**STAFF REPORT  
(Preliminary Plat)**

**CASE NUMBER:** SUB2025-00005 – MERIDIAN VILLAGE ADDITION (CITY)

**LOCATION:** East along South Meridian Avenue and 1/4-mile south of West 55th Street South (District IV)

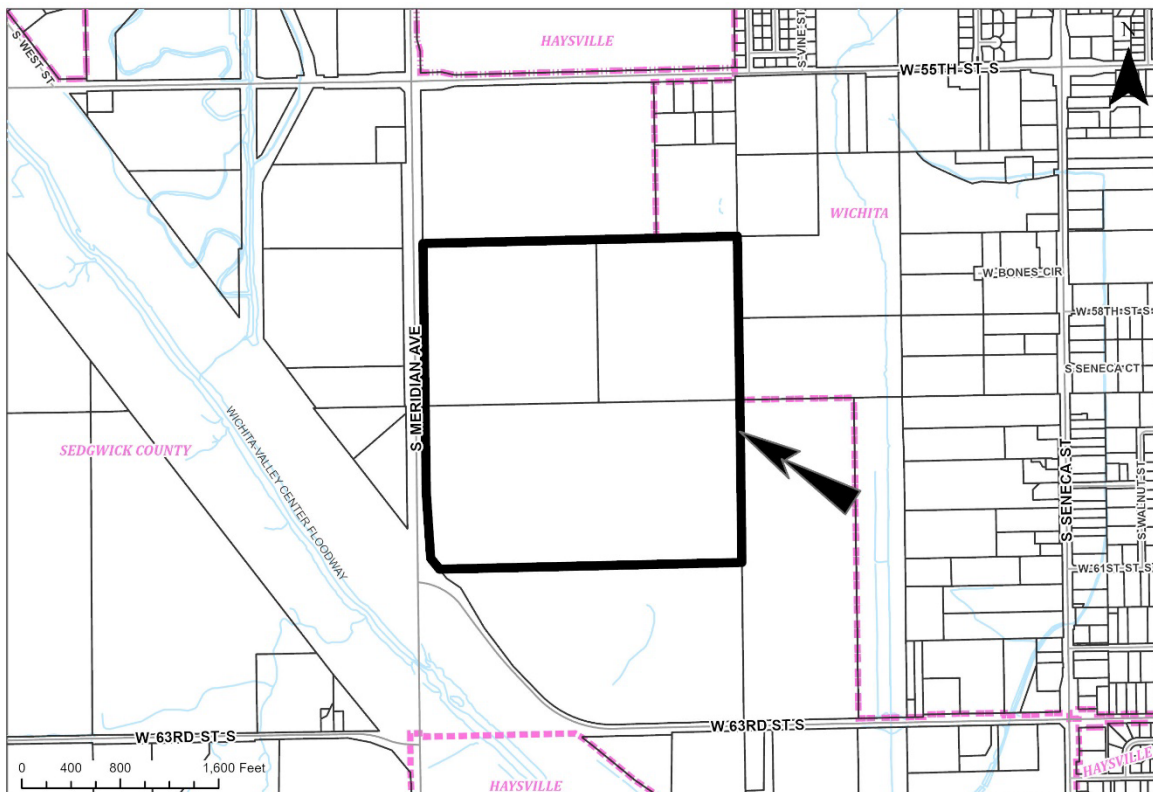
- 1) The applicant requests a MODIFICATION/WAIVER of the lot depth-to-width ratio of the Subdivision Regulations for Lots 41 and 42, Block 6, and Lot 8 Block 21. The Subdivision Regulations Section 7-204(D) states that the maximum depth of all residential lots shall not exceed 2.5 times the width.

1. Requires that water and sanitary sewer be extended to all Lots and Blocks.
2. Water transmission & sanitary sewer main (acquisition) fees are due for all Lots and Blocks.
3. A utility plan is requested w/ sanitary sewer planned depths. Additional easement may be requested once it has been reviewed.
4. Request information regarding access to sanitary sewer for this plat.

1. Any modifications in the existing storm sewer in Meridian will require a Highway permit.
2. Advises the applicant shall guarantee the closure of any existing driveway openings located in areas of complete access control. A Driveway Closure Certificate in lieu of a guarantee may be provided.
3. Approves of the connections to the north, south and east.
4. Recommends 75ft of access controls along streets connecting to Meridian.

1. City Fire Department requests verification of proper hydrant location and protection and following specifications for fire apparatus access roads.

2. City Fire Department requires for developments of one or two family dwellings where the number of dwelling units exceeds 30 shall provide two separate and approved fire apparatus access roads. When City Fire requires two fire apparatus access roads, they shall be placed a distance apart following D107.2.
3. WFD approves, no additional comments.

1. Traffic calming elements will be needed for all streets. Traffic Engineering will work with agent on details
2. Openings and Access Controls are approved.

1. Proposed “Jacob” is too close to existing “Jacobs”. Name to be revised and recommends “Hickham St.”

1. There are two block 1’s, one of these blocks needs a new block number.
2. The lot east of Lot 33, Block 2 is missing the lot number.

3. The 140' KG&E Easement in Reserve's A, B, and C scales 150 feet.
4. The dimension along the south line of Lot 1, Block 2 needs corrected.
5. The dimension along the south line of Lot 1, Block 5 needs corrected.
6. The dimension along the west line of Lot 20, Block 6 needs corrected.
7. Dimension needs added along the west line of Lot 21, Block 6 at the north end.
8. Dimension needs added along the centerline of Saint Clair Avenue, south of 59th Street South intersection.
9. Dimension needs added along the centerline of Saint Clair Avenue, north of 60th Street South intersection.
10. Jameson Court should be Jameson Circle.
11. 60th Court needs right-of-way width dimension added.
12. In the legal description "developed" needs changed to "described".
13. The paragraph under the legal description "All easements" needs changed to "All public easements".
